Model: Ko-P1		Date: 13-Mar-19	No.: RM0BY001
Subject: FSM correction on manual adjustment of print head position		Prepared by: H. Morishima	
From: 1st System Biz Promotion Sec., IP Business Center			
Classification:	<input type="checkbox"/> Troubleshooting	<input type="checkbox"/> Part information	<input type="checkbox"/> Action required
	<input type="checkbox"/> Mechanical	<input type="checkbox"/> Electrical	<input checked="" type="checkbox"/> Service manual revision
	<input type="checkbox"/> Paper path	<input type="checkbox"/> Transmit/receive	<input type="checkbox"/> Retrofit information
	<input type="checkbox"/> Product Safety	<input type="checkbox"/> Other ()	<input type="checkbox"/> Tier 2 <input type="checkbox"/> Tier 0.5

Service Manual Correction:

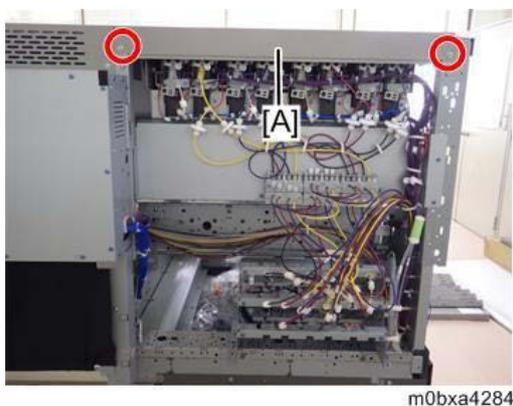
Especially check the step below carefully to prevent this trouble when changing configuration to 4C+W.

1. Remove the screws from the left upper cover [A].

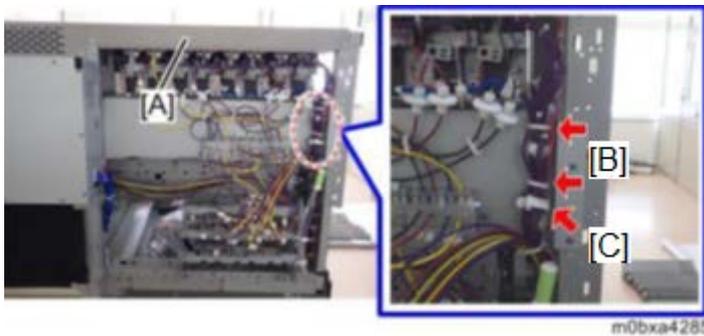
- Unclasp the Harness clamp [B] and disconnect the Cable harness [C] then remove the left upper cover [A].

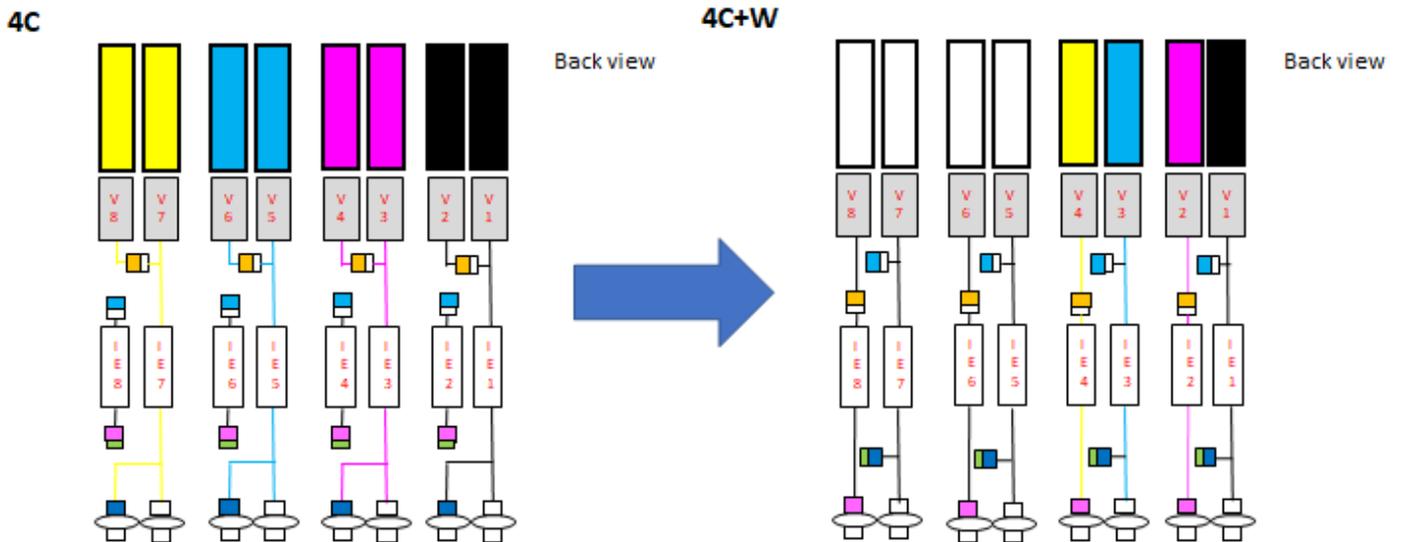
This is block diagram of the above procedure.

- 3. Replacement and Adjustment >Ink Supply Unit >Procedure of Color Change >Tubes Connection Procedure for the 4C Model

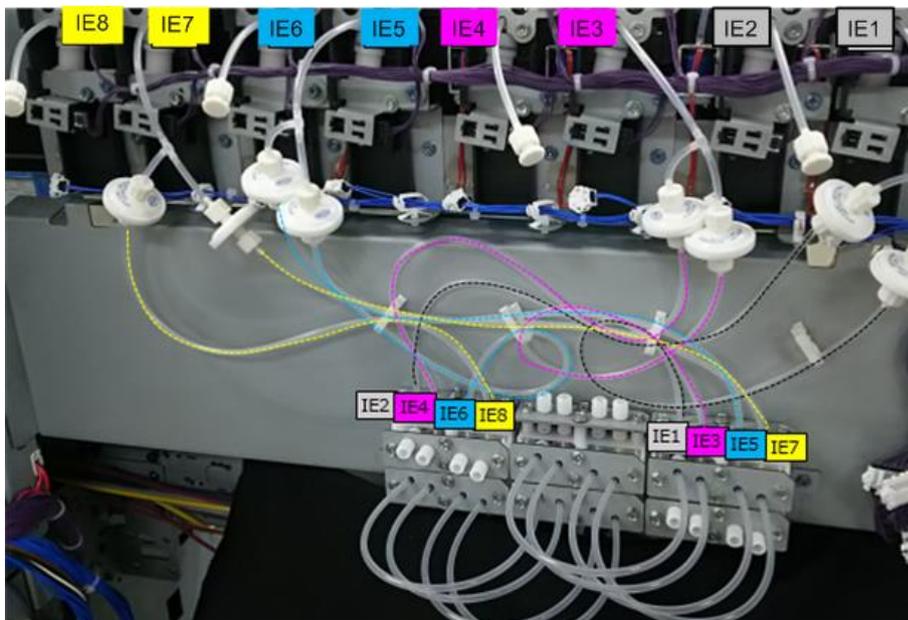
Additional step is in red-

- 1.** Remove the rear left cover.
 - 2.** Remove the left upper cover [A].
 - 3.** Attach the sealing materials (MTLLP-2) [B] to the joint [A] of the tube extending from the ink end detection [IE2].
 - 4.** Connect the joint [E] branching from the T-shaped joint [D] and the joint [C] of the tube extending from the solenoid valve [V2].
- The picture below shows the solenoid valve V1/V2.

m0bxa4318

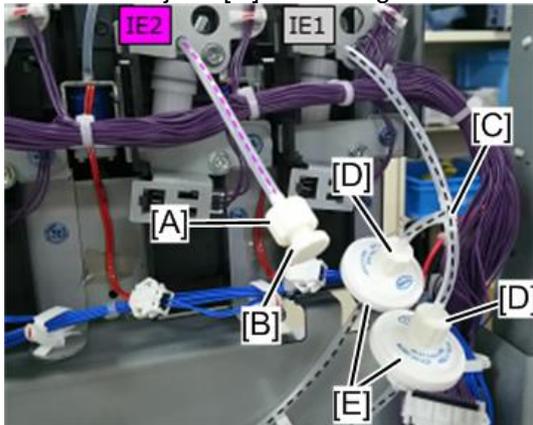
- 5.** Attach the sealing materials (FTLLP-1) [B] to the joint [A] of the tube extending from the ink end detection [IE2].
- 6.** Connect the joint [D] branching from the T-shaped joint [C] and the joint of the filter upper side [E].

m0bxa4319

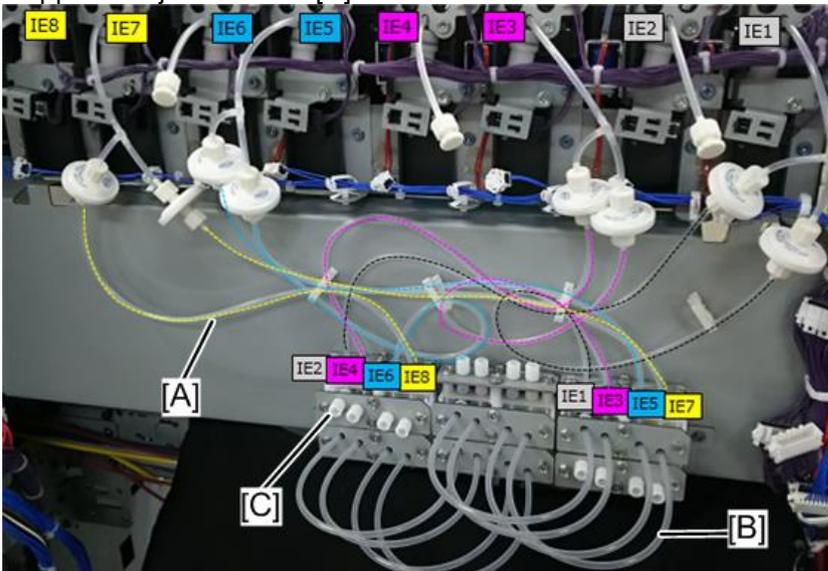
- 8. Connect the eight tubes for solenoid valve [A], the eight tubes for joint section [B], and the 12 stoppers for joint section [C] as shown below.

m0bxa4323

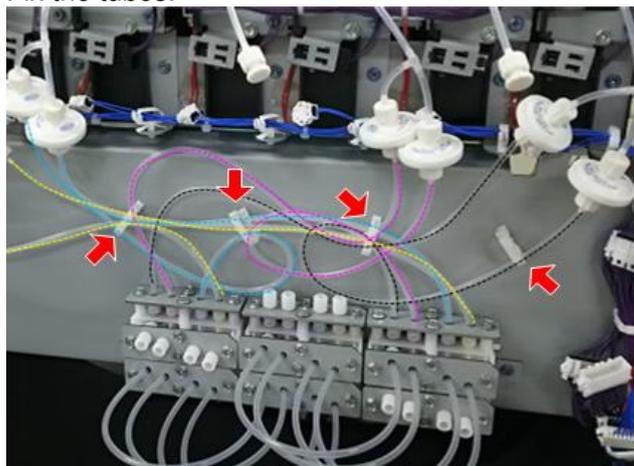
- 9.** Tighten all the loosen screws in step 7.
- 10.** Fix the tubes.

m0bxa2169

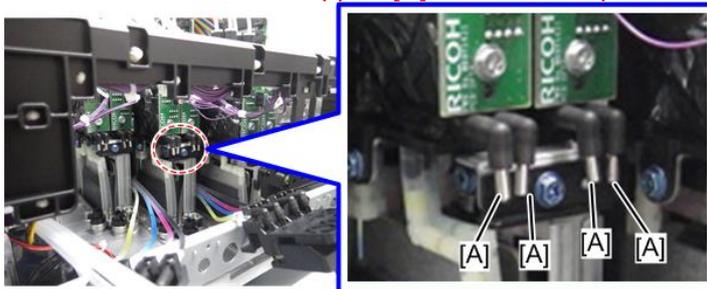
16. Attach the four rubber stoppers[A] to circulation port for head 2.

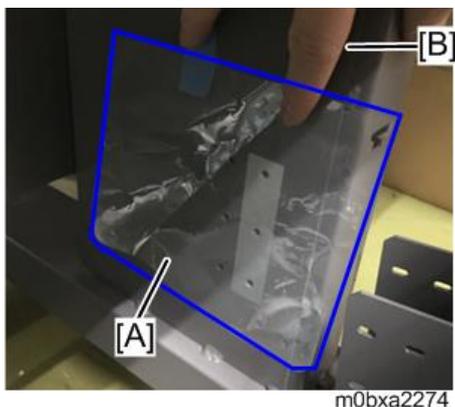
[A]: The right end of the sheet is out of the front side of the stand and the extra length is 10 to 15 mm. (approx. 0.394 to 0.591 inch)

[B]: The upper end of the sheet exceeds the height of the T-shaped hole [C] by 5 to 10 mm. (approx. 0.197 to 0.394 inch)

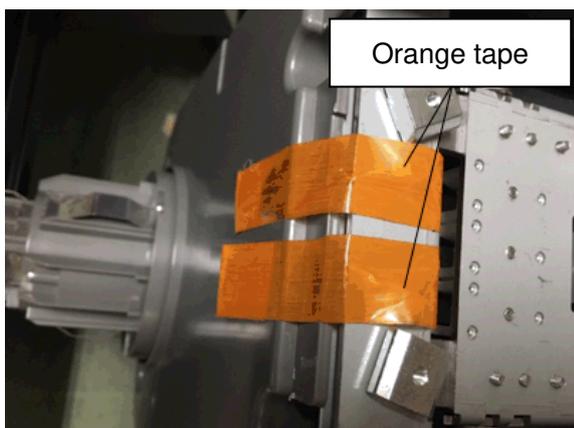
The small white rubbers[A] may drop off when inserting the nuts of the roll holders / roll core holders into the grooves [B] of the stay. The absence of the rubber might lower the power of fixing the holder to the stay.

The design change has been applied and the orange tapes has been stuck on the rubbers like picture below.

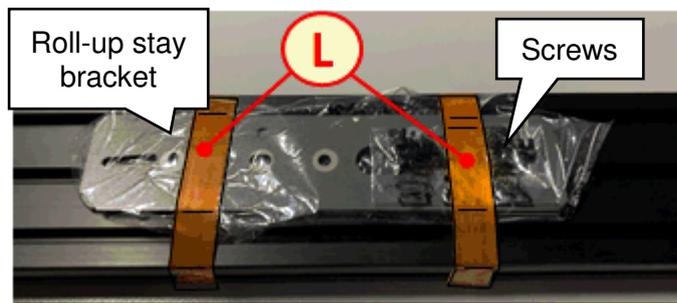
- Layout after changed

The screws listed in below tables are attached on the roll-up stay with a tape.

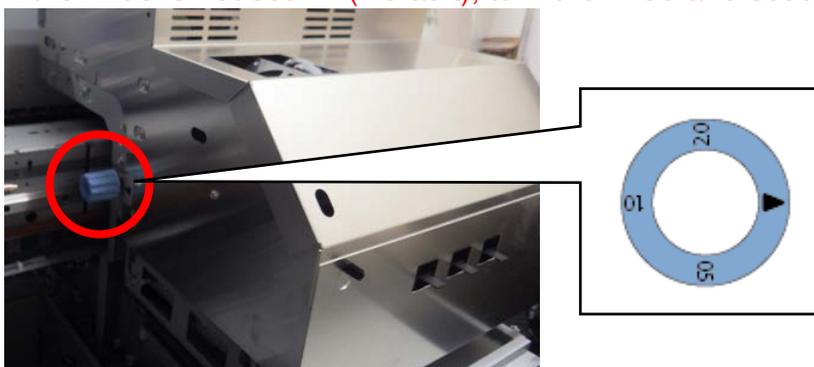
- 7.** Check the head height adjustment knob is set “▶” (Default).
If the knob is not set “▶” (Default), turn the knob and set the carriage to “▶” (Default).

m0bxa2202

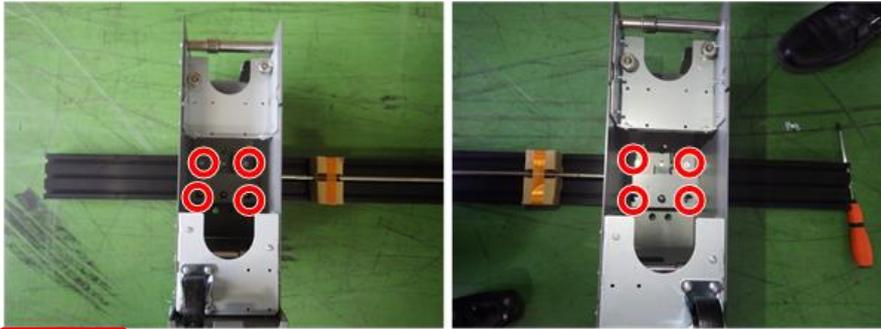
- 2. Installation > Main Machine Installation > Installing the Cure Heater (P.74)
 5. Fix the cure heater. (~~TAPPING SCREW: 4X8~~ **TAPPING SCREW:ROUND POINT:4X10**)

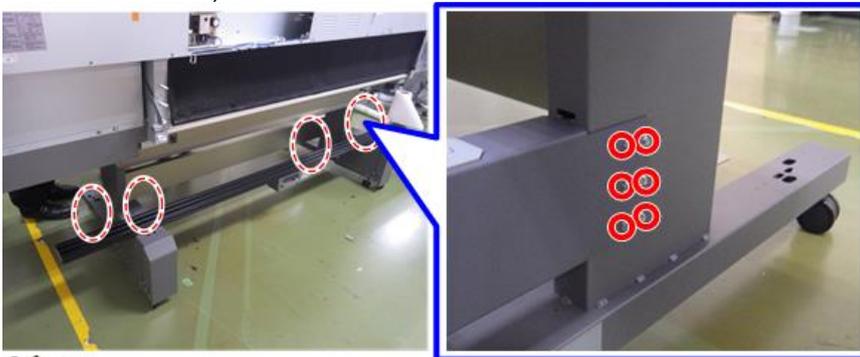
- 17.** Fix the inside and outside of the paper feed support stays (left/right) with the screws.
 (~~HEXAGONAL BOLT:DOUBLE SCREW:M4X12~~ **SCREW:SPRING WASHER:ROUND POINT:M4X10**)

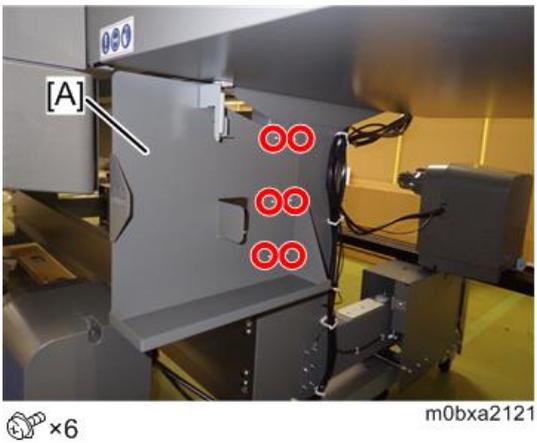
- 3.** Fix the waste ink bottle holder [A]. (HEXAGONAL BOLT:DOUBLE SCREW:M4X12
SCREW:SPRING WASHER:ROUND POINT:M4X10)

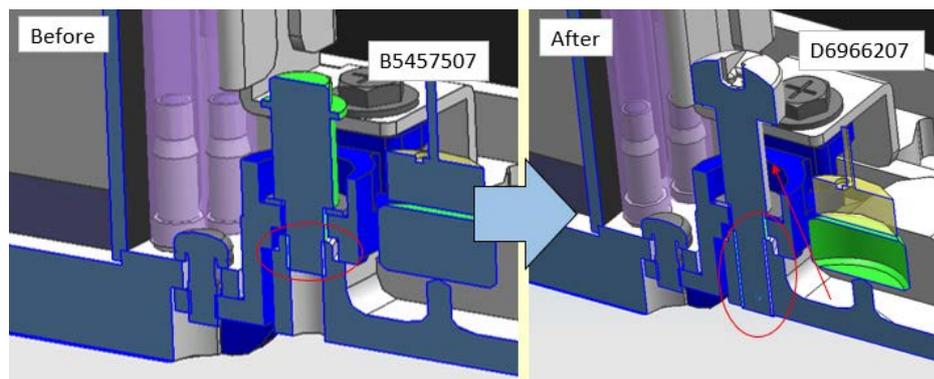
The screws which fixing print head on the carriage have been change.

- When replacing any parts of the above, replace them as a set.
- Parts quantity described above is required for per a print head.
- The spring(M0BY2165) is necessary only at front side.

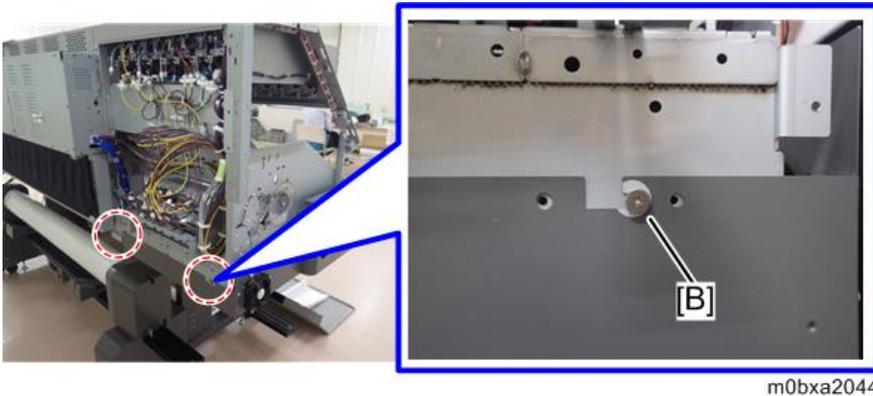
2. Fix the left bottom cover. (TAPPING SCREW:ROUND POINT:4X10)

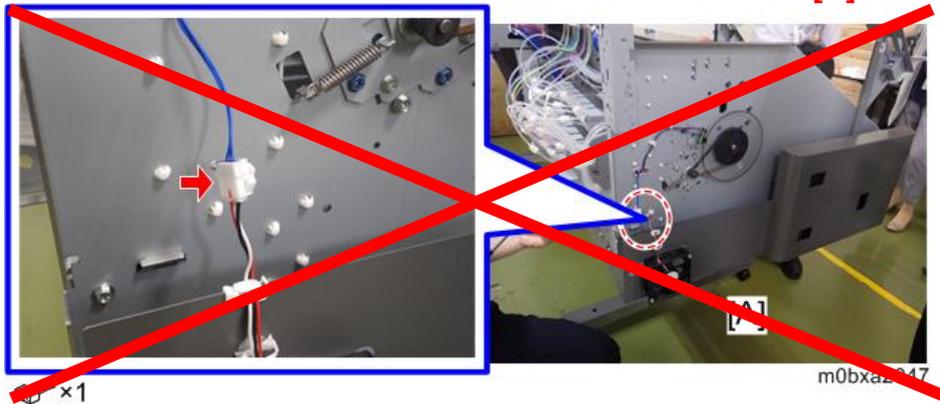
~~**3. Connect the connector of the internal ventilation fan [A].**~~

Carriage Drive Motor

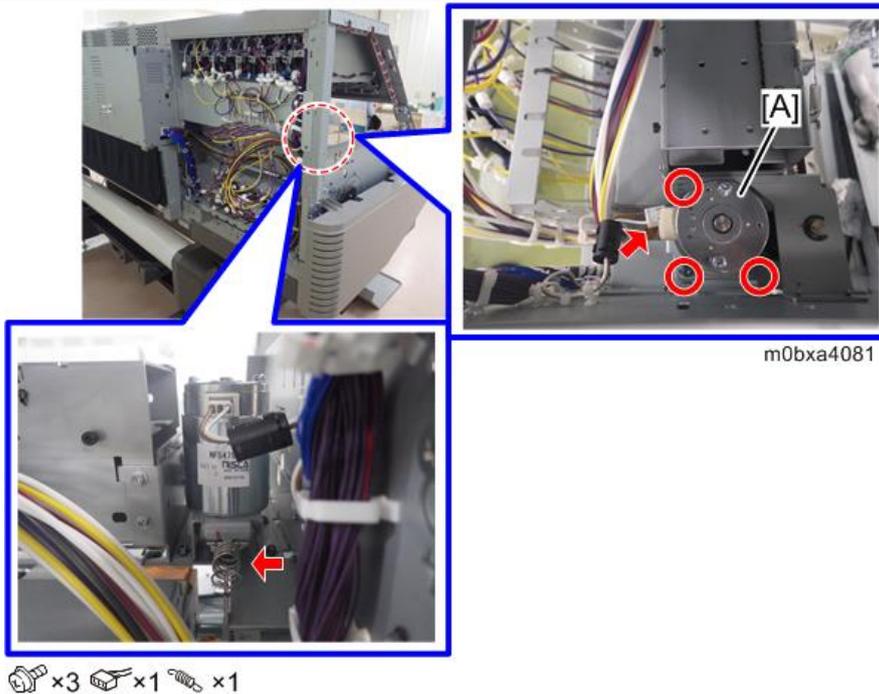
1. Remove the rear left cover.
2. Remove the left side upper cover.
3. **Release harnesses of carriage drive motor and fan from the harness clamp.**
